# Final EIS Errata

## **2 ERRATA**

**Initial F-22 Operational Wing Beddown Final EIS**

**Figure LA3.12-1**  
**Land Uses Within the Langley AFB Noise Contours**

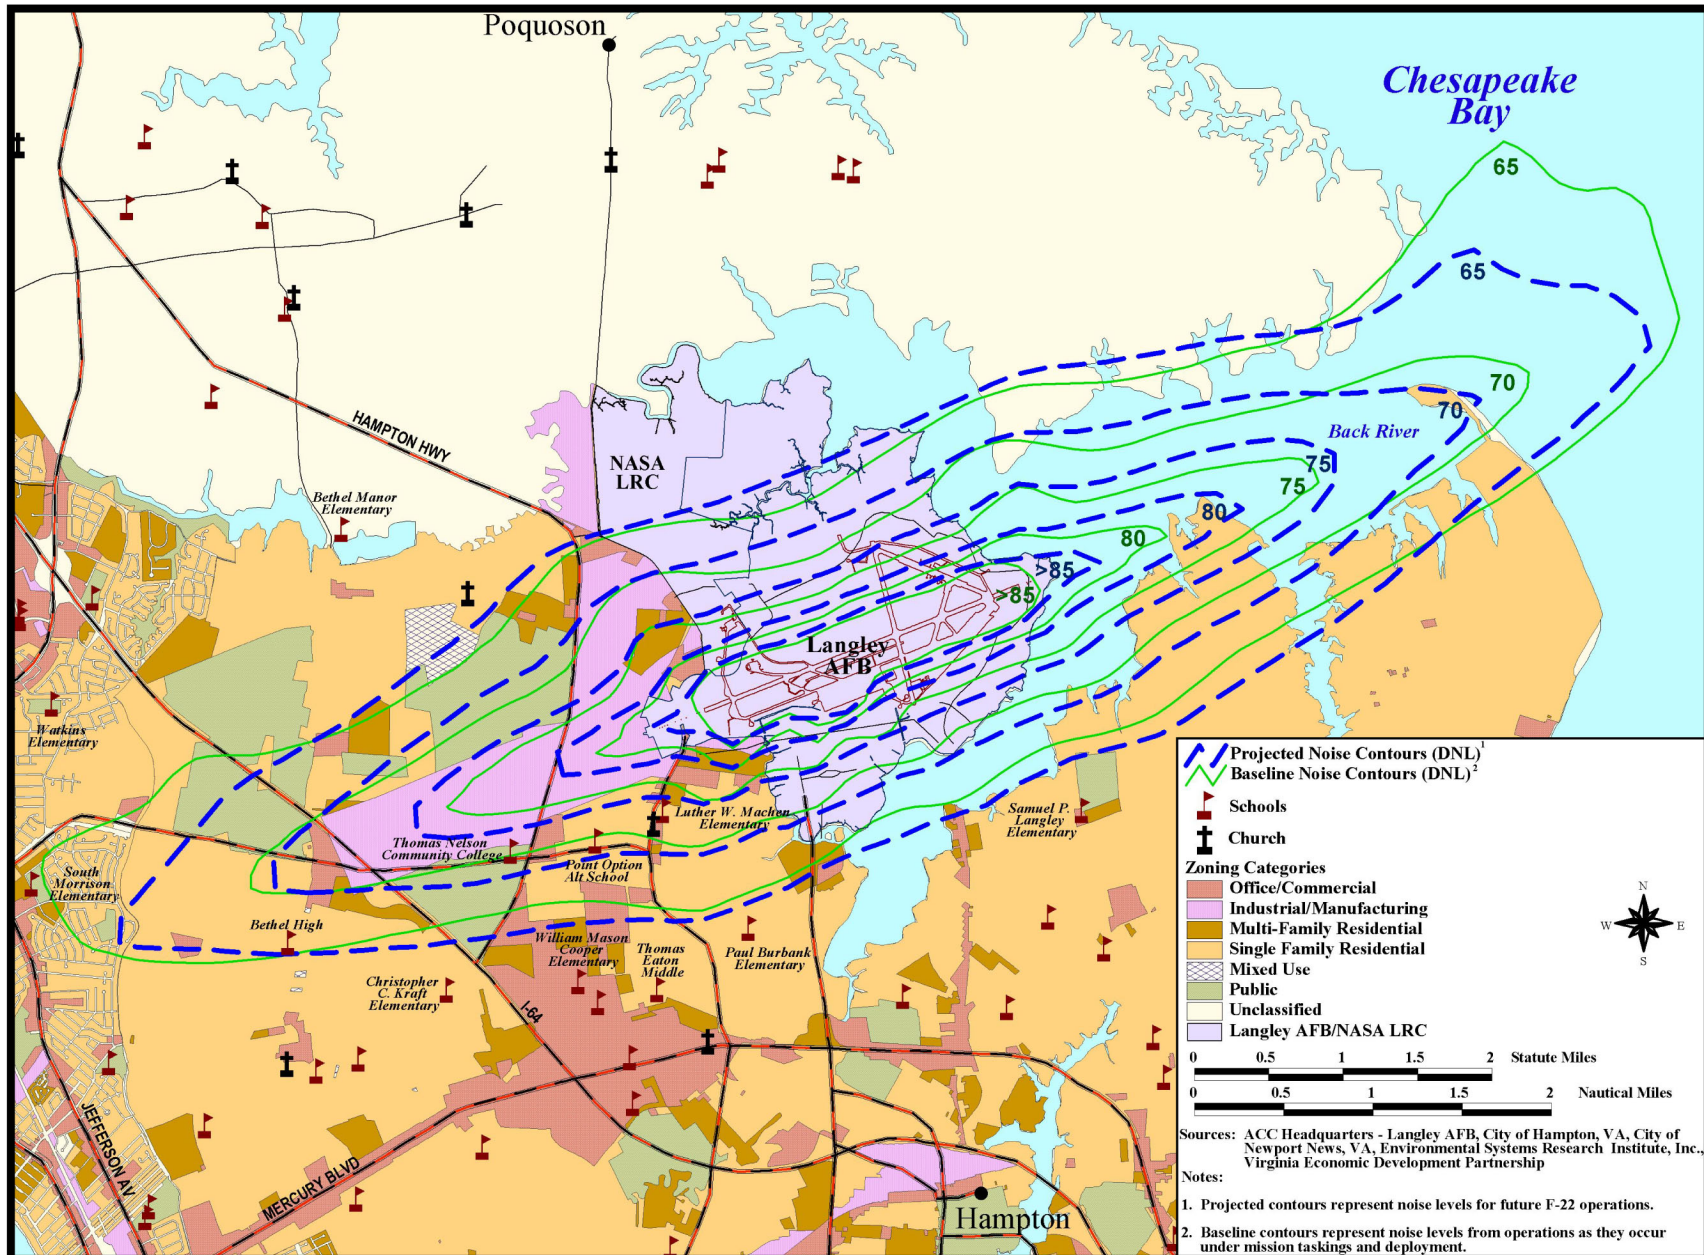
<u>Insert at end of second sentence:</u> “(refer to Figure 3.12-1).”
		<u>Insert page with Figure LA3.12-1.</u>
